1. The specifications and drawings for Invitation No. DACW64-03-B-0009, Dredging, Turnstake Island to Rattlesnake Point in Aransas and Calhoun Counties, Texas, advertised 25 February 2003, and for which bids are to be opened on 27 March 2003, are hereby modified as follows:

**QUESTIONS FROM CONTRACTORS AND ANSWERS BY THE GALVESTON DISTRICT TEAM.**

**GULF INTRACOASTAL WATERWAY, TEXAS,  
TURNSTAKE ISLAND TO RATTLESNAKE  
POINT IN ARANSAS AND CALHOUN  
COUNTIES, TEXAS, DREDGING**

TO BE ADDED TO SHEET NO. 11 OF 14

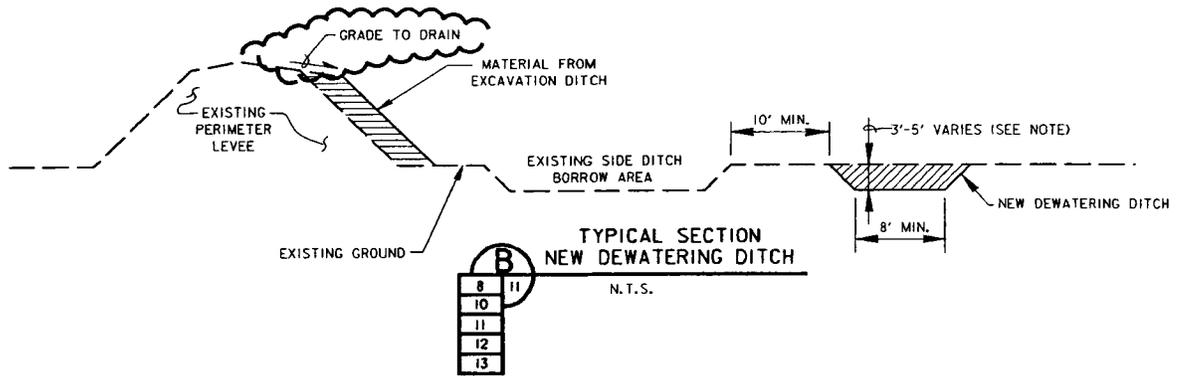
(2) SKETCH NO. 1. - The enclosed SKETCH NO. 1 shall be added to and become part of Sheet 11 of 14 of this Invitation.

1. COMPLETED DITCH EXCAVATION SHALL BE TO THE DEPTHS REQUIRED TO PROVIDE AN INVERT GRADE WHICH WILL DRAIN TOWARD THE EXISTING DROP OUTLET STRUCTURE.
2. THE DEWATERING DITCHES SHALL BE EXCAVATED TO A MINIMUM DEPTH OF 3 FEET BELOW ADJACENT EXISTING GROUND AT ALL LOCATIONS ALONG THE ALIGNMENT. DEEPER EXCAVATION WILL BE REQUIRED AT SOME LOCATIONS TO ACCOMPLISH DRAINAGE, AS SPECIFIED.
